# **Mobile Pentium® II Processor Specification Update**

Release Date: September 1998

Order Number: 243887-002

The Mobile Pentium® II processor or the Intel® Pentium II Processor Mobile Module may contain design defects or errors known as errata which may cause the product to deviate from published specifications. Current characterized errata are documented in this Specification Update.

**Figure 1.  $V_{CC}/V_{CCP}$  Timing Requirements (Mobile)**

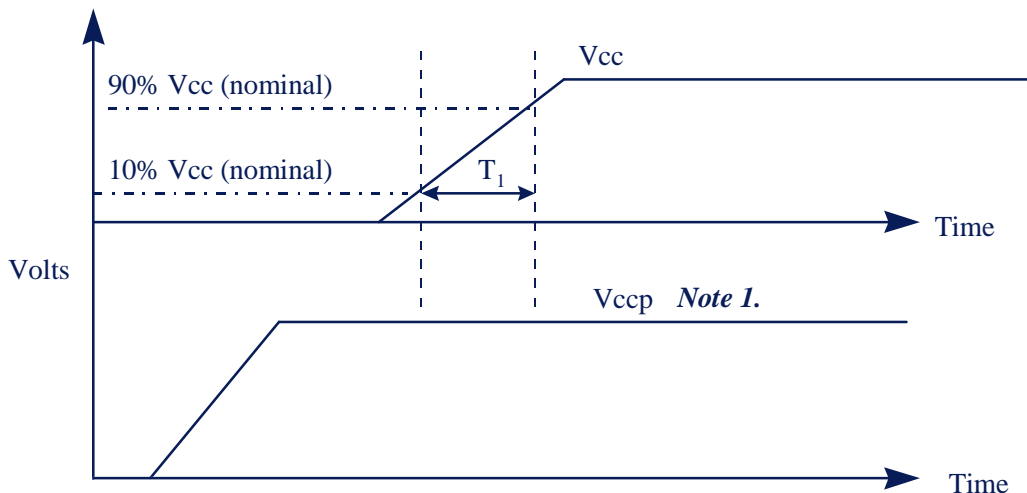
**PROBLEM:** The processor uses the PWRGOOD signal to ensure that no voltage sequencing issues arise; no pin assertions should cause the processor to change its behavior until this signal is asserted, when all power supplies and clocks to the processor are valid and stable. However, if  $V_{CC}$  ramps up before  $V_{CCP}$ , it will cause the processor to enter an invalid state.

**WORKAROUND:** For Mobile Pentium II processors, ensure that  $V_{CC}$  ramps after or with the L2 cache IO voltage ( $V_{CCP}$ ). If  $V_{CCP}$  ramps after the  $V_{CC}$ , a delay circuit can be placed on the core  $V_{CC}$  to ensure that  $V_{CC}$  ramps at the same time or after  $V_{CCP}$  as shown below in Figure 1.

**Figure 2. Workaround Flowchart: SMBALERT#-Driven System**

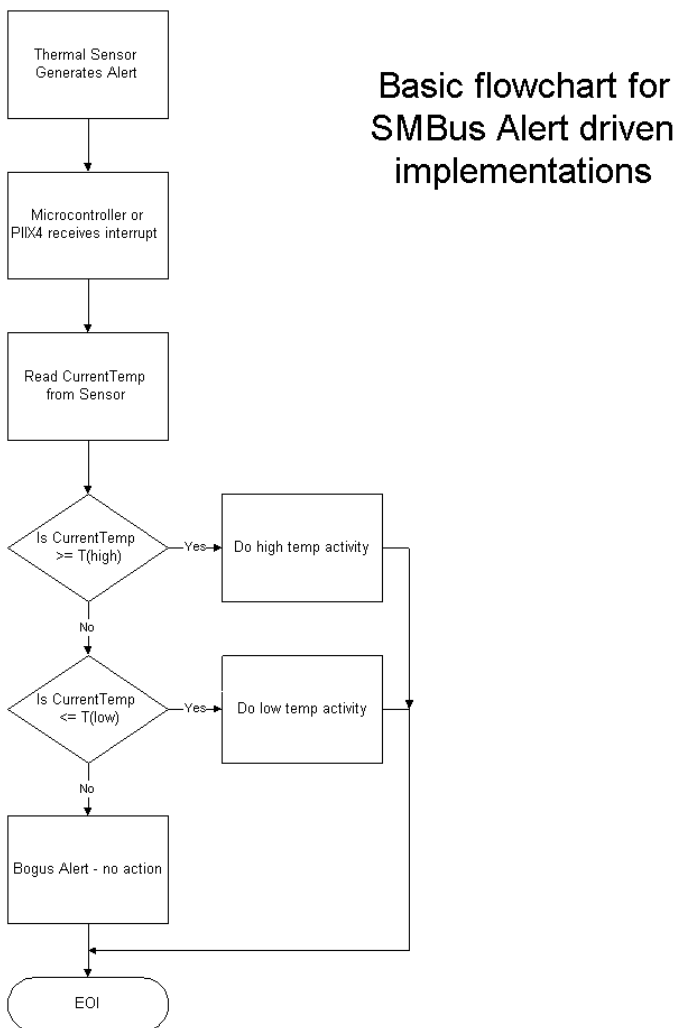
Under the conditions described below, the thermal sensor incorrectly generates the SMBALERT# interrupt. All of the following conditions must be met to trigger a false interrupt:

**WORKAROUND:** Three different (mutually exclusive) workarounds are possible:

1. Before servicing an interrupt from the thermal sensor, read and compare the processor thermal reading with the threshold limits (T<sub>HIGH</sub> or T<sub>LOW</sub>). Figures 2 and 3 provide basic flowcharts for the implementation of this workaround in an interrupt driven system.
2. If the firmware implemented polls the Status Register only, then before taking any action, re-read the temperature register and do a comparison with the alarm threshold limits (T<sub>HIGH</sub> or T<sub>LOW</sub>) to determine if the value is actually still within the temperature window.
3. Use a temperature polling scheme to monitor the processor temperature.

Figure 5.6. Cross Sectional View With Vertical Dimensions

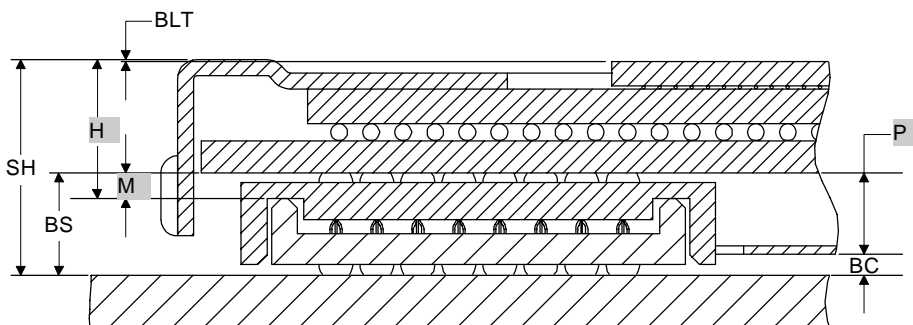
### 13. Misabeled Vertical Dimension Parameters

Figure 5.6 in the *Mobile Pentium® II Processor at 233 MHz and 266 MHz* datasheet should be replaced by the following figure:
